MEMORANDUM

TO: Montgomery County Planning Board
FROM: Staff, Urban Design Division
SUBJECT: Site Plan Review #8-89061
Shady Grove Cable (Decoverly Phase III)
R-60/TDR-10 Zone
Near the Intersection of Decoverly Drive and Diamondback Drive
Gaithersburg

Site Plan Review #8-89041
Project: Shady Grove Gable
(Discoverly, Phase II)

Preliminary Plan 1-86026
NAME OF PLAN: DECOVERLY

d. Landscaping Plan

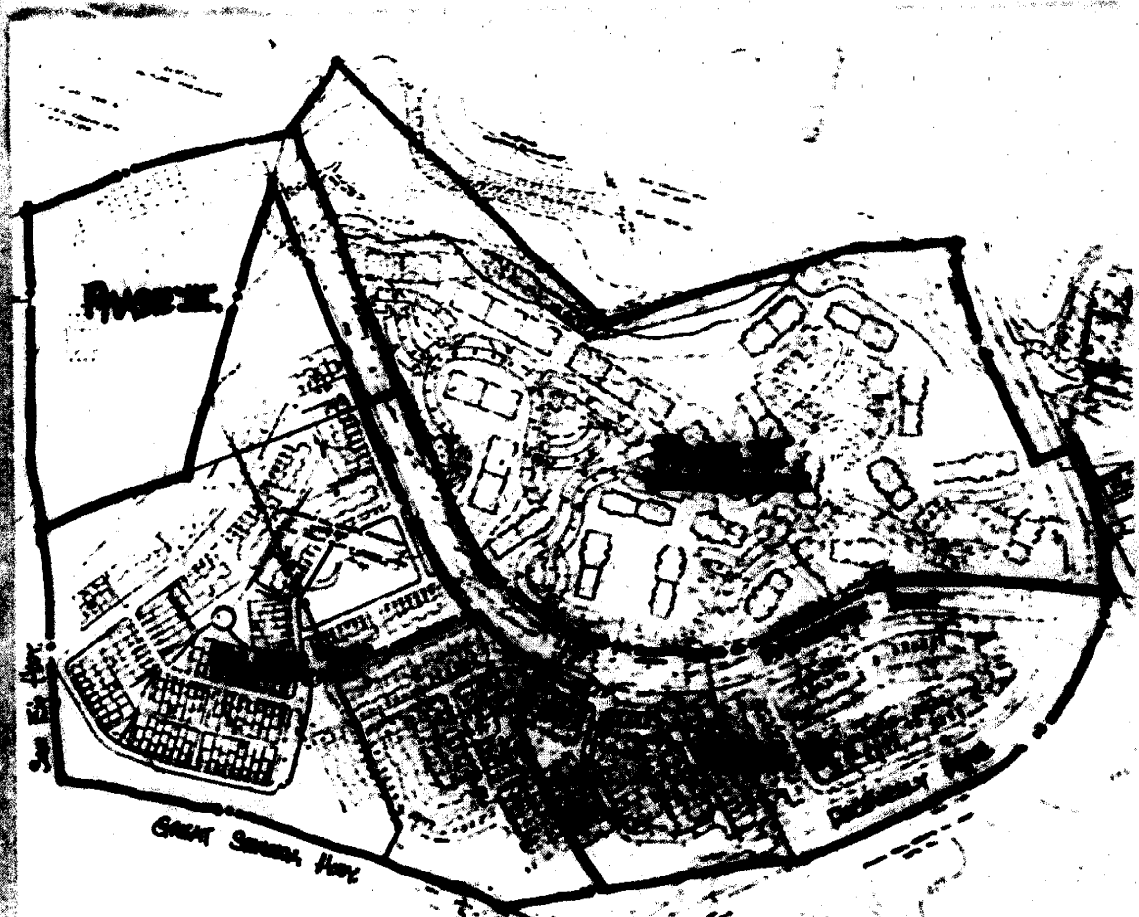
The applicant has carefully considered the landscape features for the site. Existing trees will be preserved along the small stream and near the adjacent property. Each of the vehicular entrances to the development will include special landscaping features. The parking lots include substantial landscaping in excess of the five percent required. Street trees located 45 feet on center must be provided along Diamondback Drive and Decoverly Drive adjacent to this development.
